ORKUSTOFNUN

Leiðrétting við Geological report OS82042/VOD25-B

1983-01-12

In May 1982 the report: Hólmsberg, Geological report by Skúli Víkingsson and Bjarni Kristinsson, OS82042/VOD25B, was published by Orkustofnun. The report describes the geological investigation done because of the proposed oil reservoir and harbour at Hólmsberg and Helguvík SW-Iceland, according to a contract between Orkustofnun and Almenna Verkfræðistofan.

Tunnel support chart showing 38 categoris of support which are determined by the tunneling quality (Q) and the equivalent dimension (D_e) of the excavation. Figure 3.

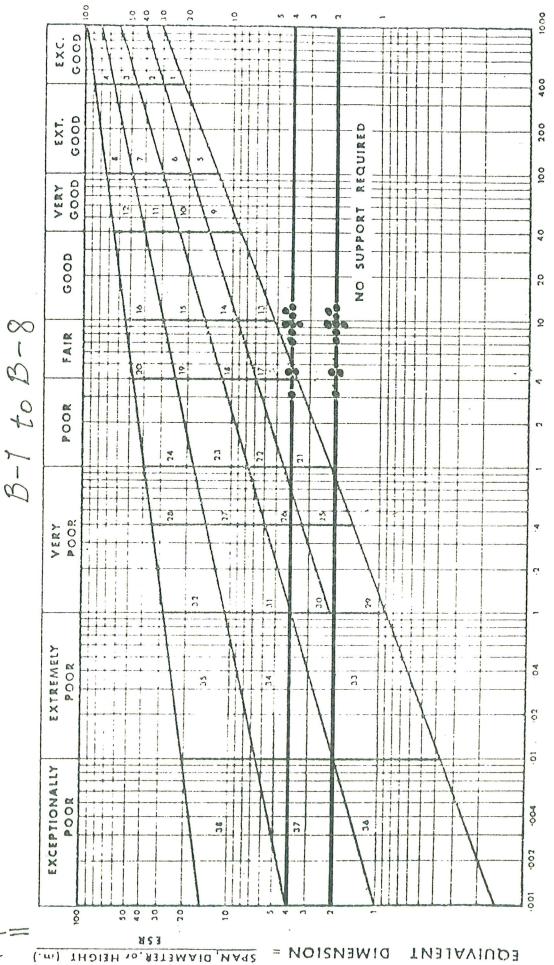
In the report mentioned above, a fault has been found in chapter 4.1, rock mass quality, but is corrected in this letter. The oil tank pits are expected to be 50 m in diameter and 10 m deep. When the tunnel support chart was made (table 2) the equivalent dimension (e.d.) was calculated incorrectly. E.d. consists of span diameter or height and excavation support ratio, E.S.R., which takes into account the purpose of excavation. In the calculation the pit diameter, 50 m, was used, instead of 10 m, the pit depth, which is the correct number. Consequently the equivalent dimension becomes 4 instead of 20 before as the worse value, and 2 instead of 10 as the better value. Enclosed there is a new and corrected copy of the tunnel support chart. The rock mass quality is of course unchanged but the equivalent dimension has decreased, thus the rock falls mainly into the "no support required" catagory. This agrees well with what it says in the text about the experience we have had concerning the stability of jointed basalts in Iceland. However, we want to emphasize what is said in the report about the danger of fall out of single columns following blasts during construction time, or later because of frost action. It is also possible that loose scoria may cause problems during construction time but is unlikely to be a major problem.

In October 1982 the report "Hólmsberg, Boreholes B-9 and B-10, by Skúli Víkingsson and Snorri Zóphóníasson, OS82092/VOD40B" was published. In this report there is among other things described the rock mass quality from the boreholes B-9 and B-10 and the result is shown on the tunnel support chart published in the aforementioned geological report. These results change in the same way as above.
